Safety Recall 70F – Toyota Camry All Weather Floor Mat Accessory for 2007 and Early 2008 Model Year Vehicles

Toyota Camry All Weather Floor Mat Involved in this recall

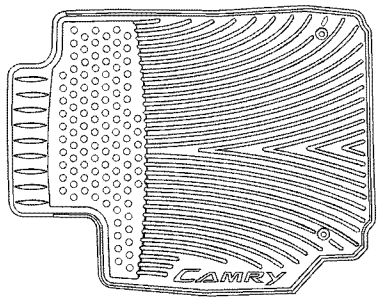
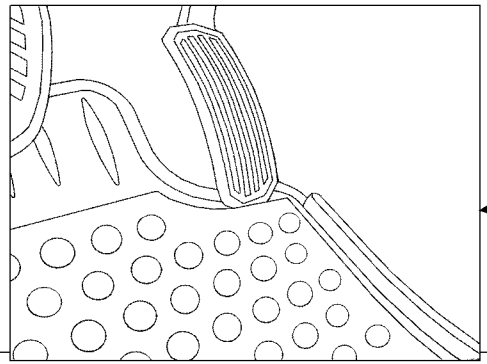
If the Toyota Camry All Weather Floor Mat is not **secured by the retaining hooks (clips)** and the mat moves forward, it may interfere with the accelerator pedal.

- In recent months, Toyota has received reports regarding the optional Toyota Camry All Weather Floor Mat (floor mat constructed from heavy duty rubber) slipping forward and interfering with the movement of the accelerator pedal. Toyota has investigated these reports and determined that if the optional Toyota Camry All Weather Floor Mat (either by itself or if it is placed on top of an existing carpeted floor mat) is **not secured by the retaining hooks (clips)** and the mat moves forward, it may interfere with the accelerator pedal from returning to the idle position. If the mat is properly secured, it will not interfere with the accelerator pedal.

- A newly designed replacement driver's seating position All Weather Floor Mat will be available in approximately mid-to-late Nov. 2007. Until the replacement floor mat is ready, a preliminary owner notification letter will be sent to vehicle owners requesting their assistance in regularly verifying the floor mat is properly secured using the retaining hooks (clips) provided. If the mat is properly secured, it will not interfere with the accelerator pedal.
